Guildford Residents Associations Response

**20/P/02155: Weyside Urban Village (Slyfield Regeneration Programme), Slyfield Green, Guildford**

*Hybrid planning application for redevelopment of part of allocated site for the Slyfield Area*

Strategic Development Framework SPD Extract

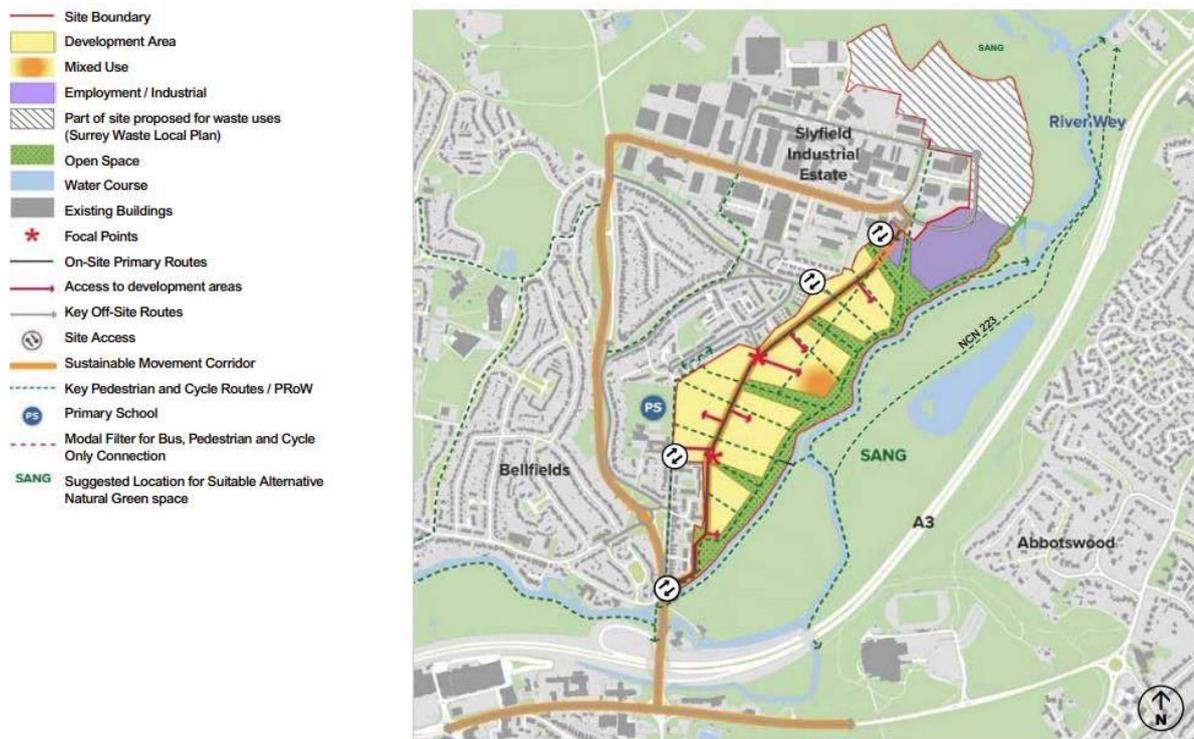
It has been a long-established principle that **the principal road running through the Slyfield Regeneration Area should be set back from the riverside boundary**. This would avoid impact on the river and adjoining habitats, prevent light pollution when looking toward the site across Green Belt and wildlife amenity areas, and better serve residents. This approach was supported by the Surrey Waste Plan inspector and reflected in the Strategic Development Framework SPD which includes the following layout:

Fig 16: Illustrative application of master plan principles to Slyfield

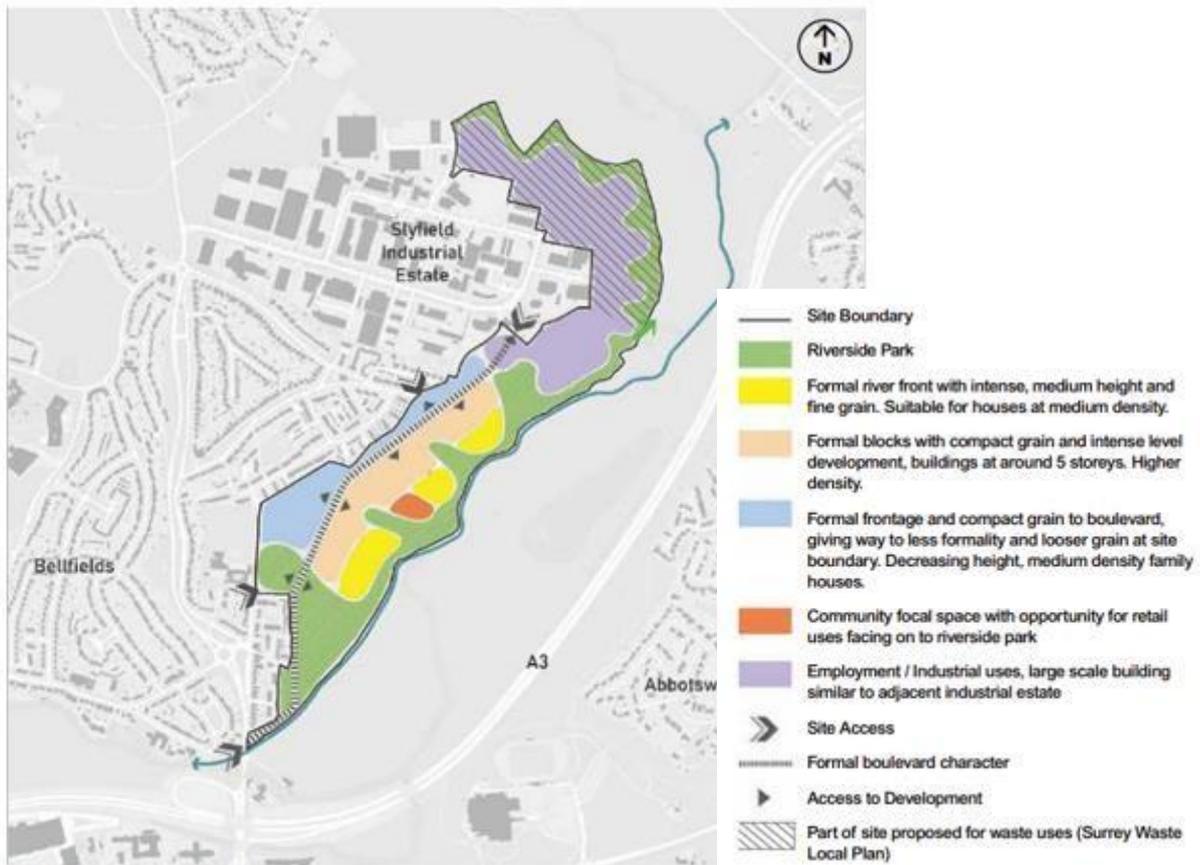
The assessment of spine road options, on pages 202-205 of the Design and Access statement, lacks credibility. It gives high weighting to creating large development blocks, gives little weight to the various impacts on the river, flood risk or accessibility for neighbourhood users, and ignores the impact of running the spine road along the “Wey Walk Community” green finger undermining its amenity value. ‘Proximity to the river’ in one section scores amber whereas ‘impact on blocks’ in a section scores red. Running the road along the river, especially raised as proposed, would have consequences for the character, amenity and environment of the Wey corridor. It would be an unnecessary and avoidable urban incursion. Light pollution and noise from traffic would be issues. There would a greater risk of runoff from the road surface onto sensitive habitat. The wisdom of a raised road section so close to the river is also questioned. It would have consequences for the flow of water to and from the river with knock on effects on where water collects in this flood prone part of the site. Culverts tend to block during events and create maintenance issues. It is also notable that the area in question is shown as a green space in the Strategic Development Framework SPD.
